**The Project Participants:**

**Response to the request for review for the CDM project activity  
“Changshu Haike HFC 23 Decomposition Project”  
with the registration number 1105**

December 2, 2007

Fig.1: HCFC 22 Storage tank

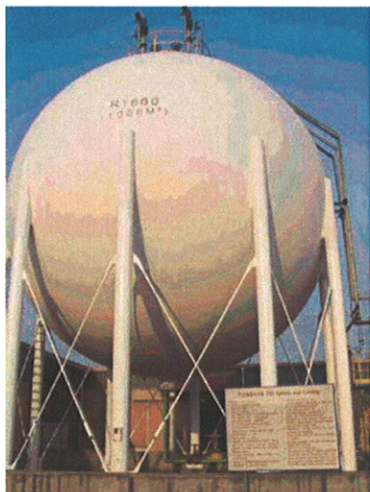
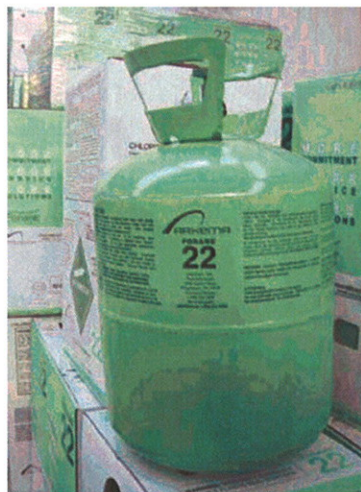
3. **Issue 3: The Validation report states that “Through the site-visit, the total annual production of the existing HCFC 22 facility were confirmed to be 7,937.7 tons in 2002, 13,179.3 tons in 2003 and 18,106.5 tons in 2004 respectively, from checking the monthly and daily data sheets, including the inventory of HCFC 22 and the amounts filled in the containers”. Further clarification is required in relation to amounts filled in the containers and source, purpose and use of those containers.**

Our clarification: HCFC 22 annual production verification by the DOE was achieved by crosschecking the consistency of the daily production records, the monthly-consolidated reports and the amounts of HCFC 22 stored in the “containers”, which are the storage tanks, the iso-containers and the disposables. The inventory of HCFC 22 is the quantity of HCFC 22 stored in the storage tanks (Fig.1), in the disposables (Fig.2) and in the iso-containers (Fig.3) ". The storage tanks, Iso-containers and disposables are the necessary parts of the facility for the production, transportation and selling of HCFC 22. The storage tanks are used for intermediate storage. The Iso-containers and disposables are filled for transportation to customers. The plant has three storage tanks with a total capacity of about 1300 MT. Each Iso-container has a capacity of about 18 MT. The number of Iso-containers can vary depending on sales plan. We have two types of disposables: 22.7 kg and 13.6 kg depending on customers' request.
